# Access Compliance Report

## Public Rights-of-Way

Intersection ID: 20039	Main Street: PROVIDENCE_RD	Cross Street: MAMMOTH_OAKS_DR	Location: NE
ADA ID: DF525C9E4103	Ramp Type: PerpDiag	Initial Pass/Fail: Fail	Overall Compliance: No
		Severity Score: 25

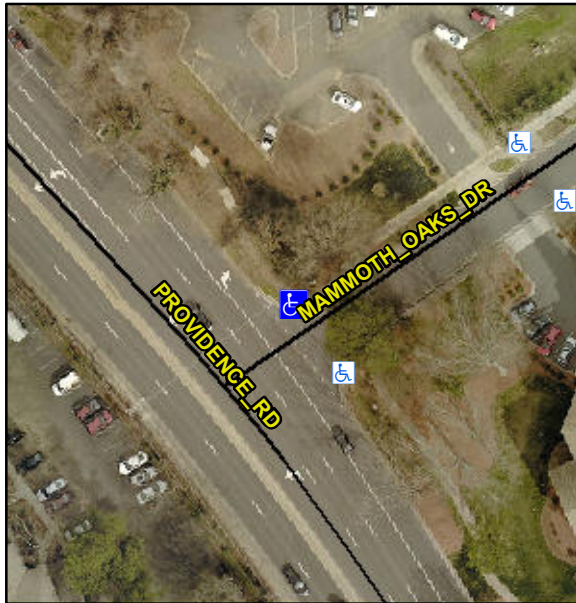
**Not Found, R304.5.3**

Compliance	Description	Data	Compliance	Description	Data
N/A	Ramp Length (in)	58.0	Yes	Ramp Slope (%)	6.7
Yes	Ramp Width (in)	48.0	No	Ramp XSlope (%)	8.0
N/A	Flare Type LT	N/A	N/A	Flare Type RT	N/A
N/A	Flare Slope LT (%)	N/A	N/A	Flare Slope RT (%)	N/A
N/A	Flare Traversable LT?	N/A	N/A	Flare Traversable RT?	N/A
N/A	Landing Length (in)	N/A	N/A	DWS Provided?	N/A
N/A	Landing Width (in)	N/A	N/A	DWS Contrast?	N/A
N/A	Landing Slope (%)	N/A	N/A	DWS Length (in)	N/A
N/A	Landing X Slope (%)	N/A	N/A	DWS Full Width?	N/A
N/A	Landing Curb? (Y/N)	N/A	N/A	DWS Offset (in)	N/A
N/A	Shared Landing?	N/A			
N/A	Gutter Ponding?	N/A	N/A	Gutter Slope (%)	N/A
N/A	Gutter Lip Ht (in)	N/A	N/A	Gutter X Slope (%)	N/A
N/A	Painted X Walk1?	No	N/A	Painted X Walk2?	No
	X Walk 1 Direction	To SW		X Walk 2 Direction	To SE
N/A	X Walk 1 Width (in)	N/A	N/A	X Walk 2 Width (in)	N/A
	X Walk 1 Slope (%)	5.0		X Walk 2 Slope (%)	2.3
	X Walk 1 X Slope (%)	4.8		X Walk 2 X Slope (%)	7.5

**Remove & Replace Curb Ramp With Two New Directional Ramps or Equivalent.**
